## APPLICATION FOR MODIFICATION ASSESSMENT REPORT

<b>Application Number:</b>	Mod2022/0275
<b>Responsible Officer:</b>	Anne-Marie Young
<b>Land to be developed (Address):</b>	Lot 1 DP 228962, 1 Drew Place BELROSE NSW 2085 Lot 2 DP 228962, 1 Drew Place BELROSE NSW 2085
<b>Proposed Development:</b>	Modification of Development Consent DA2020/1072 granted for Construction of a Seniors Housing development, including demolition works, new access driveway and front fence
<b>Zoning:</b>	Warringah LEP2011 - Land zoned R2 Low Density Residential
<b>Development Permissible:</b>	Yes, under Pursuant to SEPP (HSDP)
<b>Existing Use Rights:</b>	No
<b>Consent Authority:</b>	Northern Beaches Council
<b>Delegation Level:</b>	DDP
<b>Land and Environment Court Action:</b>	No
<b>Owner:</b>	Newpro 19 Pty Ltd
<b>Applicant:</b>	Newquest Property

The application seeks consent for a modification of development consent, DA2020/1072, which approved the demolition of all structures and construction of six (6) x two (2) bedroom/two storey infill self-care housing units and at grade parking for 6 vehicles pursuant to the provisions of SEEP (Housing for Seniors or People with a Disability (HSPD)). The subject mod

**Approved first floor plan showing Units 5 and 6**

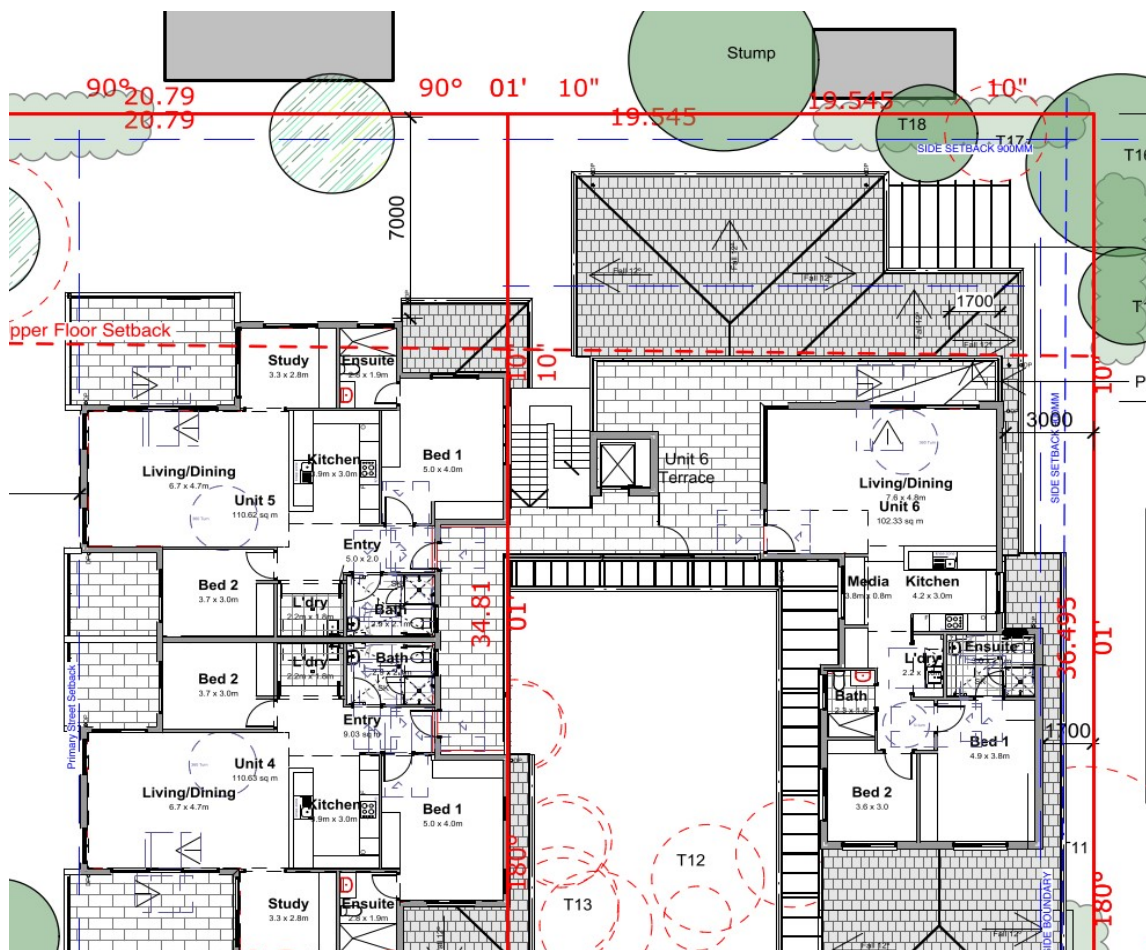
The proposal seeks to delete Condition No.12(a), which required privacy treatment to Unit 6 as per the recommendation of DSAP.

The elevated balcony to Unit 6 measures 49sqm and is positioned 8.4m from the northern boundary and 3.0m to the eastern boundary, refer to first floor plan below.

Valid concerns have been raised in submissions from neighbours regarding privacy impacts associated with the deletion of the condition requiring a privacy treatment along the edge of the elevated balcony. For greater detail, please refer to the submissions section.

In order to ensure that the design continues to provide a high level of visual and acoustic privacy for the occupants and neighbours, in accordance with the recommendation by DSAP, it is recommended that the condition be amended to require a 400mm high privacy screens along the northern edge of the upper floor balcony of Unit 6 and a 4.0m long full height screen to the balcony to Unit 5 (Refer to detailed discussion in the Referral section of this report).
